**From:** [Yu, Olivia, EMNRD](#)  
**To:** [Graham, Rick](#); [Yolanda Jimenez](#)  
**Cc:** [Griffin, Beau G](#); [Nash, Brett](#)  
**Subject:** RE: [EXTERNAL] RE: Key release  
**Date:** Friday, July 27, 2018 11:19:00 AM

Thank you for the data. As many of the delineation sample locations still have chloride levels exceeding permissible 600 mg/kg at 2 ft. bgs, please note that additional vertical delineation will need to proceed in depth. Also, the impacted area needs to be extended laterally, West of sample locations #10, #14, and #16 to complete horizontal delineation.

Key Atha SWD tank battery. 70 bbls prod. Water on site. Rick Graham 713-651-4437. Event occurred 5/10/2018. Will submit C-141.  
30-025-08816.

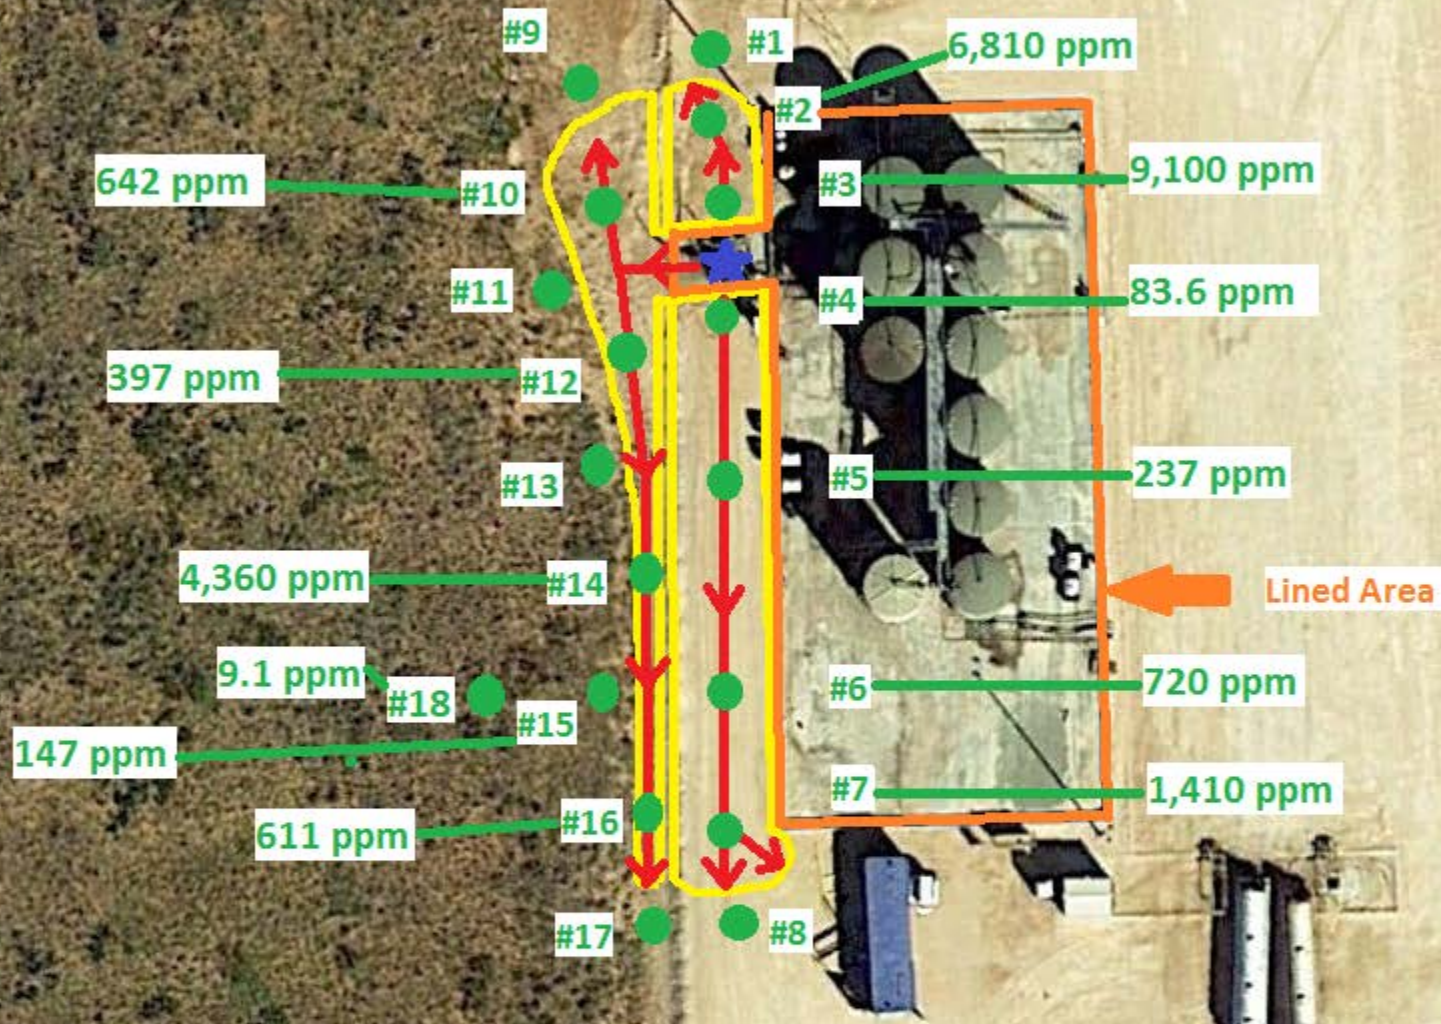
1. Please indicate the release point on a scaled map. Is the area under the filter pot lined?
2. Is the limit of the release area at the caliche berm? Please verify that the release did not impact the pasture (i.e., photos).
3. Please be advised that vertical delineation must proceed further than 2 ft. bgs if BTEX, TPH, and chloride permissible levels are exceeded. Permissible chloride levels are 600 mg/kg.
4. Soil samples representing the horizontal extent of the release must be collected as well. If the levels of BTEX, TPH, and chlorides exceed permissible levels at the edges of the identified release area, the sample area must be extended

- laterally, including West of the caliche berm.
5. Provide GPS coordinates of the sample locations.
  6. Provide NMOCD at least 48 hours advance notice for an opportunity to witness soil sampling processes.

1. Please indicate the release point on a scaled map. Is the area under the filter pot lined?
  - **Yes, the area under the release point is a lined cement structure. Please see the map provided in the attached remediation plan for the exact point of release.**

2. Is the limit of the release area at the caliche berm? Please verify that the release did not impact the pasture (i.e., photos).
  - **After corresponding with Key operations, we now understand the caliche berm (not part of tank battery secondary containment) had a breach directly to the west of the release point which allowed the released liquids to reach the pasture to the west of the caliche berm. Please refer to the revised remediation plan/map to view the updated affected area and the additional sample locations to reflect these changes. An attached photo of the release area is also attached for reference.**

- **Vertical delineation will proceed further than 2 ft. bgs if BTEX, TPH and chloride levels are exceeded at 2 ft. bgs at any sample location.**
4. Soil samples representing the horizontal extent of the release must be collected as well. If the levels of BTEX, TPH, and chlorides exceed permissible levels at the edges of the identified release area, the sample area must be extended laterally, including West of the caliche berm.

- **Please refer to the revised remediation plan/map to view the updated affected area and the additional sample locations including those extending laterally just outside of the affected area.**

5. Provide GPS coordinates of the sample locations.
  - **Please refer to the revised remediation plan/map for each sample location's GPS coordinates.**
